DOCUMENT 009214 – INTERIORS PACKAGE ADDENDA – NO. 1

- A. Project Name: St. Patrick Catholic Church.
- B. Construction Manager: Kingery Construction.
- C. Architect: Clark Architects Collaborative 3.
- D. Architect Project Number: 11008.
- E. Date of Addendum: 11-12-14

Addendum 01 - Int. Package
11-12-14
AAD-18.0

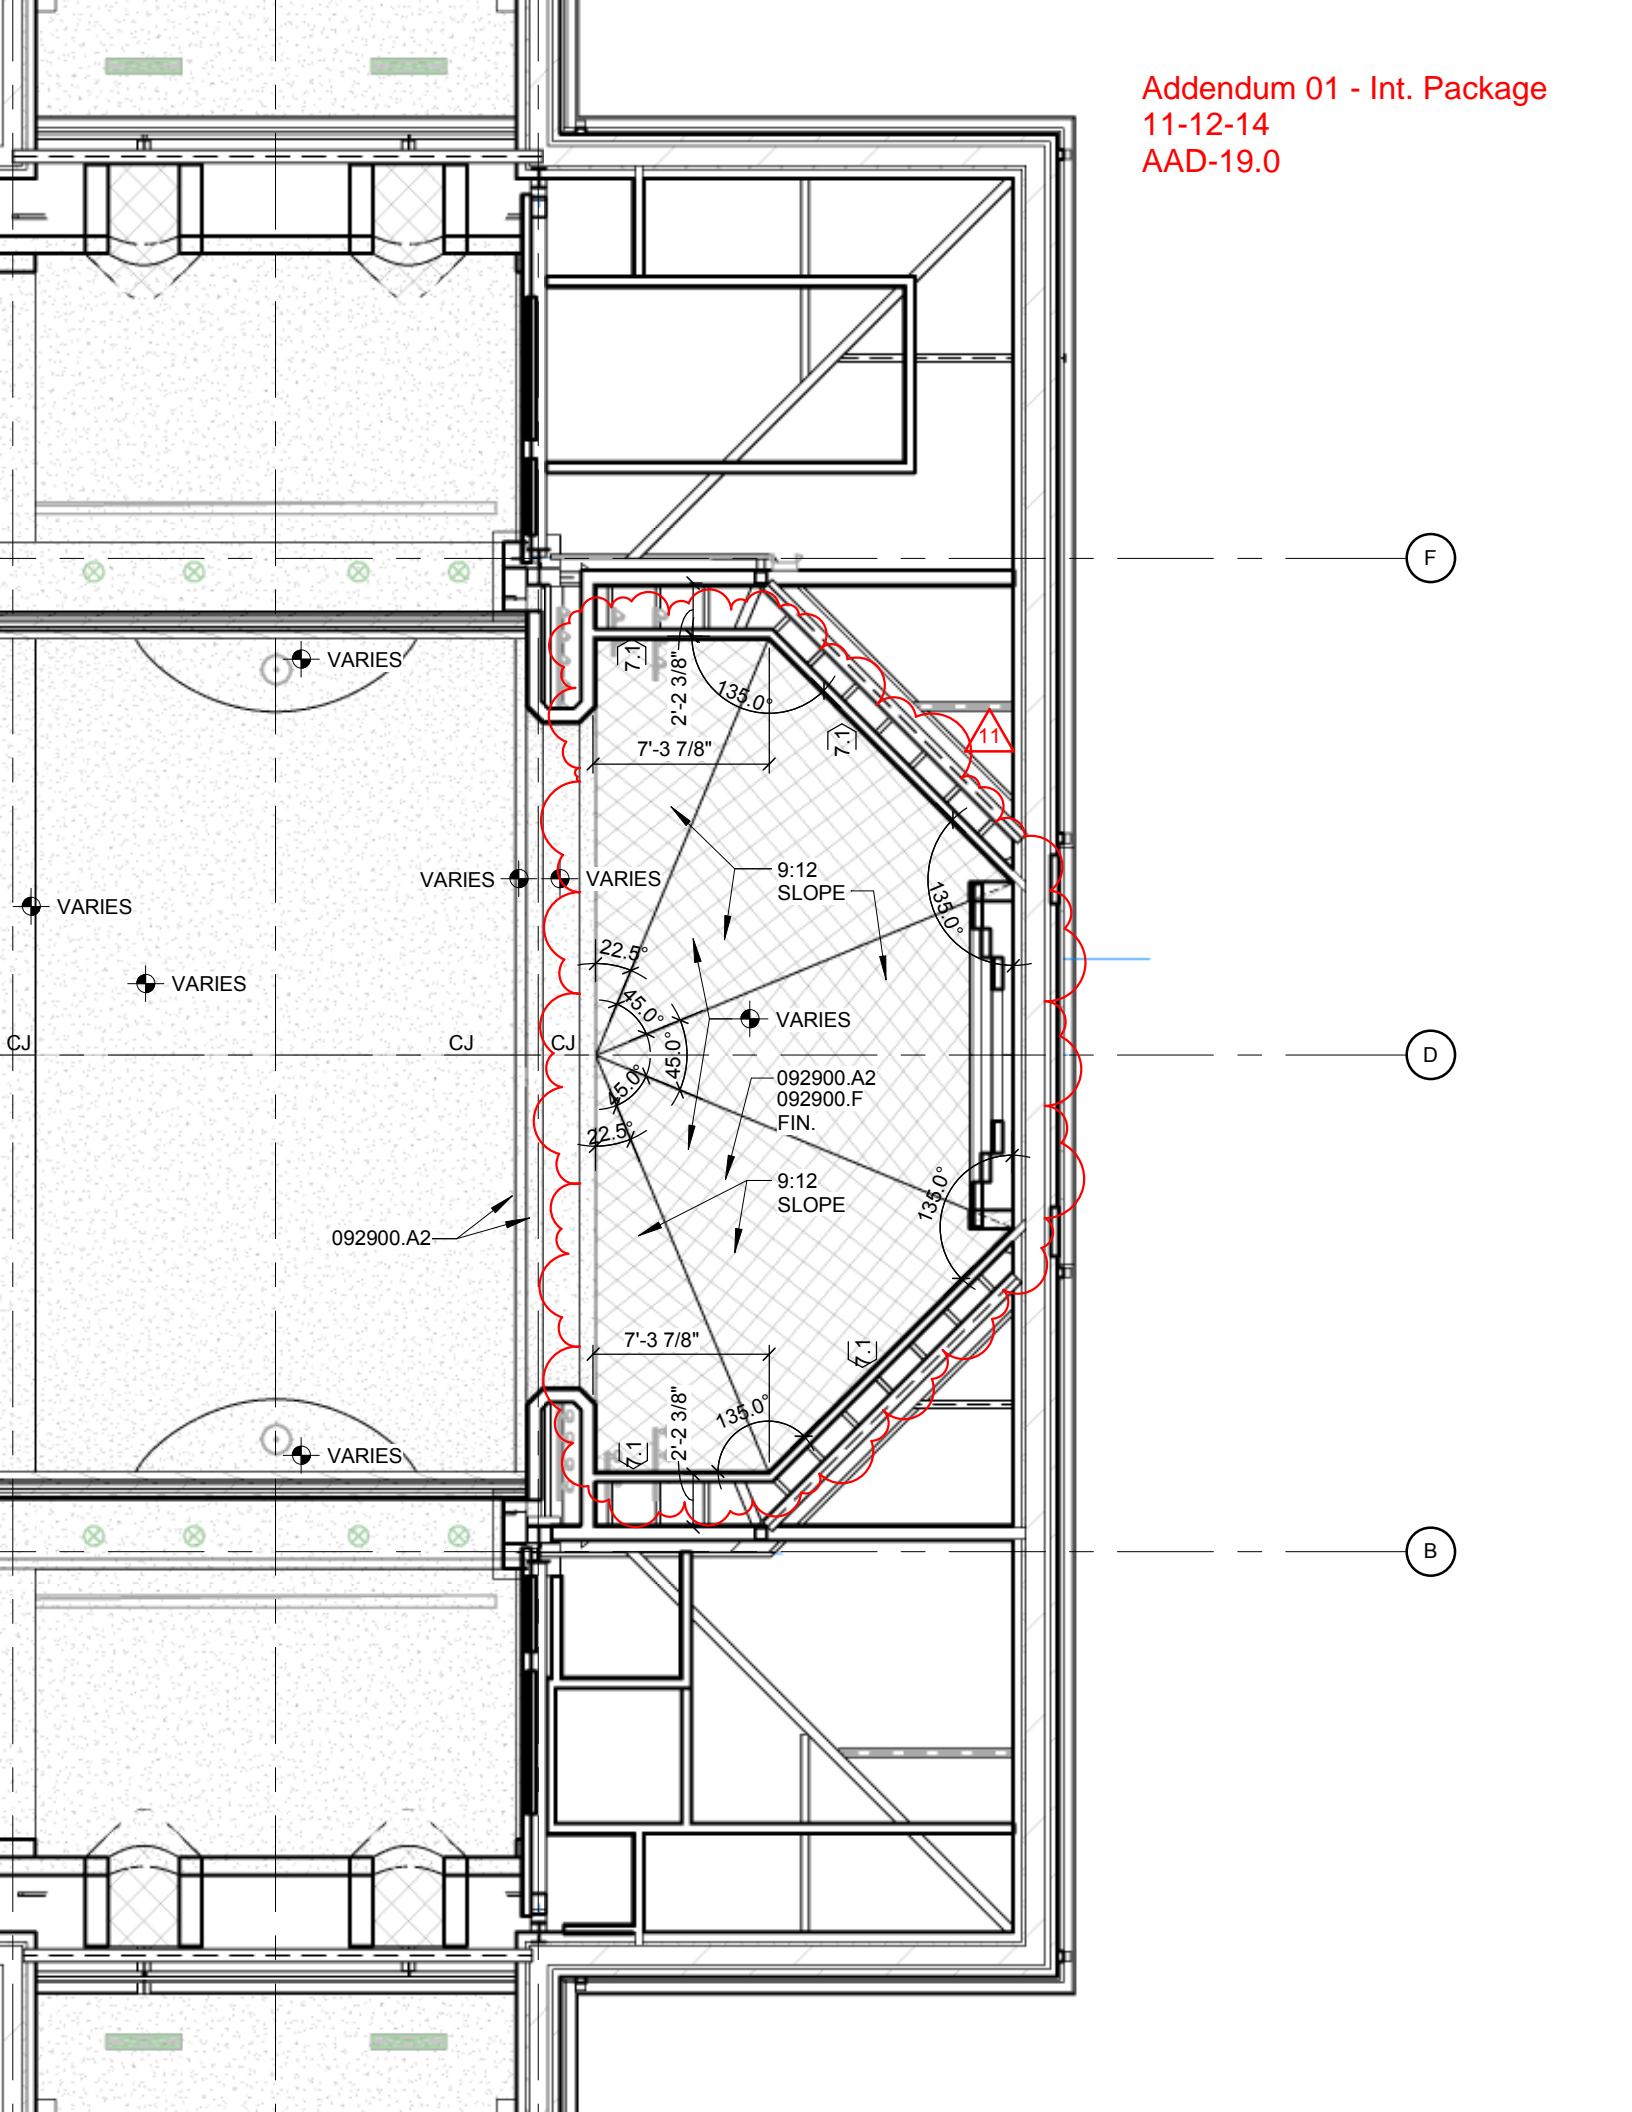
2. RCP Detail L10 has been cleaned up for clarity. See attached AAD-17.0.
 3. Revised lower Sanctuary ceiling and bulkhead finishes. Corrected ceiling elevations taken from finished Sanctuary floor. See attached AAD-18.0.

A800

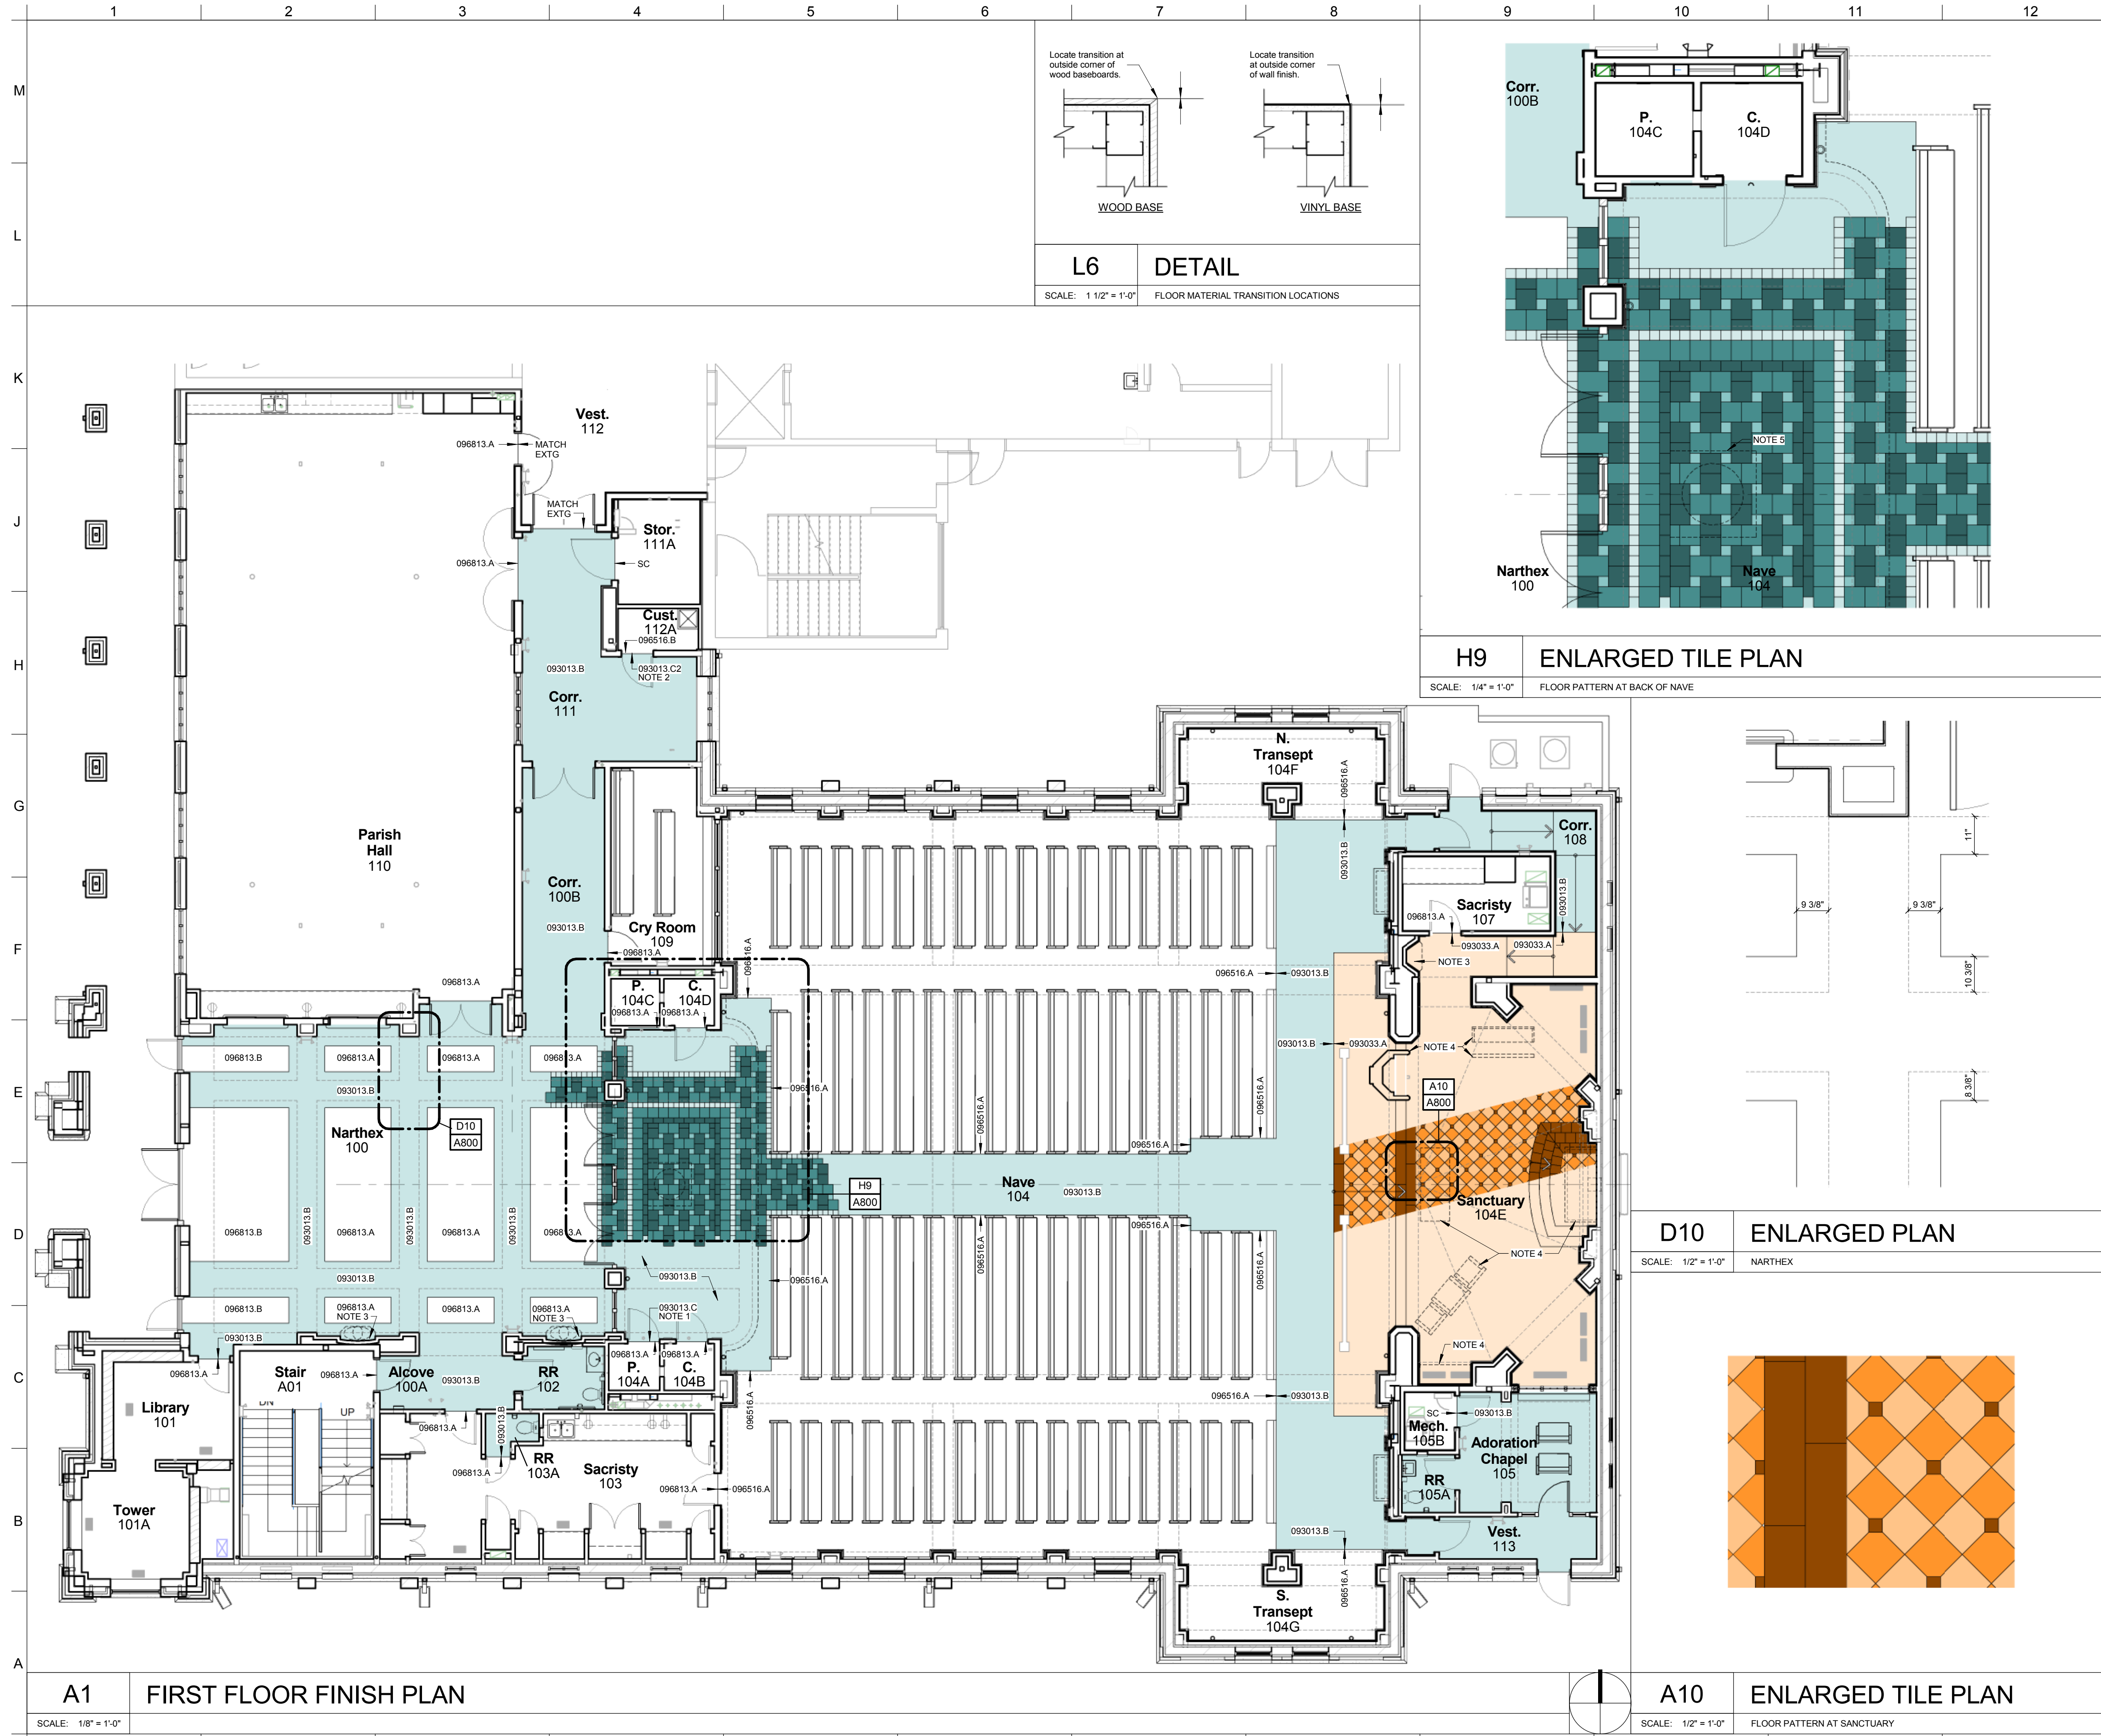
1. Floor tile patterns and transition strip detail. See attached AAD-20.0.
- L. Sheet E202 – First Floor Power Plan (not reissued).
